URGENT FIELD SAFETY NOTICE / PRODUCT NOTIFICATION

Subject: Brainlab Spine & Trauma 3D Navigation 1.0:
Potential unexpected view representation of an accurately navigated instrument that might result in user misinterpretation under specific circumstances.

Product Reference: Brainlab Spine & Trauma 3D Navigation 1.0
(subpart of the system "Navigation Software Spine & Trauma 3D, Version 3.0")

Brainlab Identifier: CAPA-20190206-002260

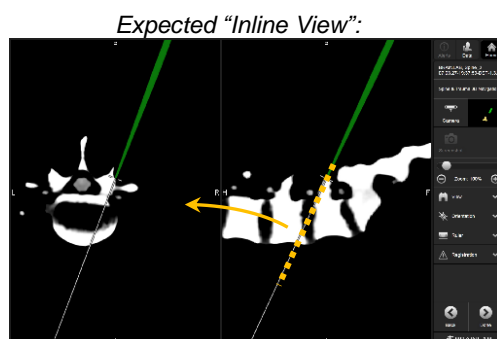
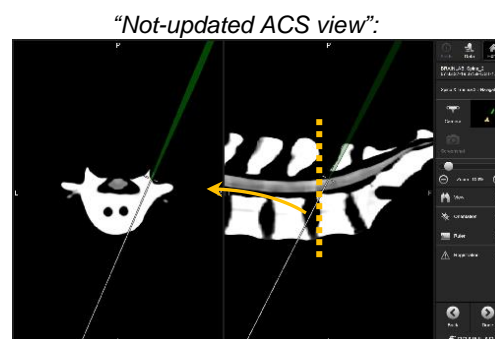
In certain occurrences, the affected navigation software application might unexpectedly display an accurately navigated instrument in an axial, coronal/sagittal (ACS) view representation with fixed planes in the image reconstruction (the "not-updated ACS view"), instead of displaying the desirable view representation "Inline View", which is commonly used for navigating invasive instruments at the spine.

In this not-updated ACS view, intended navigation might be difficult and not always appropriately possible for the user to determine the position of the instrument within the anatomy:

- Navigated instruments could be located outside the displayed anatomical slice, but would be rendered as a projection in this not-updated ACS view.
- This projected rendering could possibly create the incorrect impression that the instrument would be located within the currently displayed anatomical slice.

Brainlab has internally determined that if the unexpected view representation is not detected and the projected rendering is subsequently misinterpreted by the user, this could potentially mislead the surgeon to follow an invasive path other than the one intended.

Activate the submenu “Orientation.”

The submenu “Orientation” may be closed immediately without applying changes.

This action corrects the view representation issue for all navigated view layouts for the duration of the current patient treatment.

Figure 3: Workflow selection on an affected spinal navigation system:

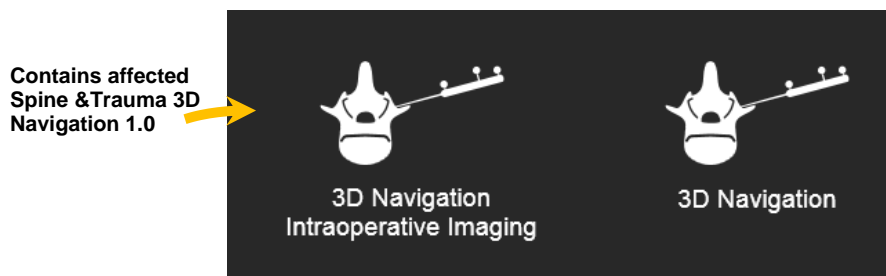
The workflow on the left includes the affected navigation application version 1.0 ("Intraoperative" workflow). If the workflow is changed during a treatment to the workflow on the right – including the navigation application version 2.6 for screw planning – and then switched back to the workflow on the left, the problem can occur in specific cases.

- Starting navigation in the "3D Navigation Intraoperative Imaging" workflow, changing the workflow to "3D Navigation" for screw planning and then returning to the initial workflow.
(*This overall workflow is intended and will be used in remote cases for users who perform intraoperative AIR registrations (e.g., 3D C-arm) using the "Intraoperative" workflow and who desire intraoperative screw planning and also desire to use selected navigation functionality of the affected application afterwards*).
- Starting with the "3D navigation" workflow (AIR App registration only) and changing to "Intraoperative" workflow.
(*This workflow is not intended*).

1. Avoid workflow changes with already registered datasets, if possible. If not absolutely necessary (e.g., for intraoperative screw planning), avoid switching between the workflow application selections “3D Navigation Intraoperative Imaging” and “3D Navigation” during one patient treatment.
2. After restarting the application with a previously registered dataset (crash restore or workflow change), **always activate and deactivate the sub-menu “Orientation” once** to ensure that the correct, expected view representations are displayed for the current session.
